Access Compliance Report

Public Rights-of-Way

Intersection ID: 15576	Main Street: LAWYERS_RD	Cross Street: IDLEWILD_RD_NORTH	Location: NE
ADA ID: CDC703F577A3	Ramp Type: PerpDiag	Initial Pass/Fail: Fail	Overall Compliance: No
		Severity Score: 8.75

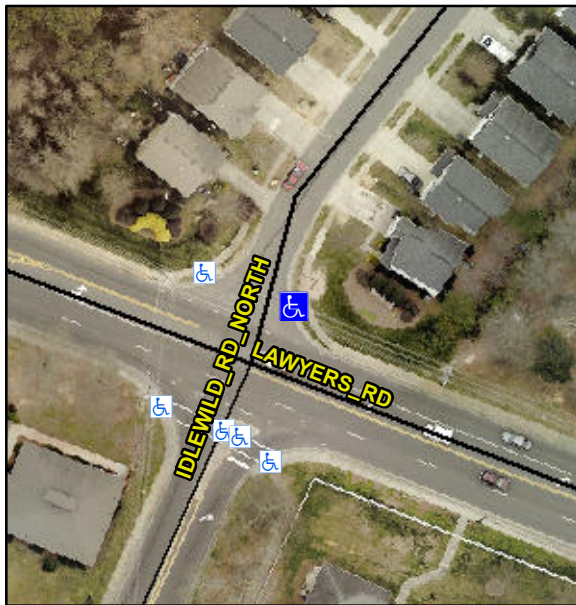
Not Found, R304.5.1

Compliance	Description	Data	Compliance	Description	Data
N/A	Ramp Length (in)	48.0	Yes	Ramp Slope (%)	7.0
No	Ramp Width (in)	47.0	Yes	Ramp XSlope (%)	2.0
N/A	Flare Type LT	N/A	N/A	Flare Type RT	N/A
N/A	Flare Slope LT (%)	N/A	N/A	Flare Slope RT (%)	N/A
N/A	Flare Traversable LT?	N/A	N/A	Flare Traversable RT?	N/A
N/A	Landing Length (in)	N/A	N/A	DWS Provided?	N/A
N/A	Landing Width (in)	N/A	N/A	DWS Contrast?	N/A
N/A	Landing Slope (%)	N/A	N/A	DWS Length (in)	N/A
N/A	Landing X Slope (%)	N/A	N/A	DWS Full Width?	N/A
N/A	Landing Curb? (Y/N)	N/A	N/A	DWS Offset (in)	N/A
N/A	Shared Landing?	N/A			
N/A	Gutter Ponding?	N/A	N/A	Gutter Slope (%)	N/A
N/A	Gutter Lip Ht (in)	N/A	N/A	Gutter X Slope (%)	N/A
N/A	Painted X Walk1?	No	N/A	Painted X Walk2?	No
	X Walk 1 Direction	To NW		X Walk 2 Direction	To SW
N/A	X Walk 1 Width (in)	N/A	N/A	X Walk 2 Width (in)	N/A
	X Walk 1 Slope (%)	1.1		X Walk 2 Slope (%)	2.8
	X Walk 1 X Slope (%)	3.8		X Walk 2 X Slope (%)	0.7

Remove & Replace Curb Ramp With Two New Directional Ramps or Equivalent.
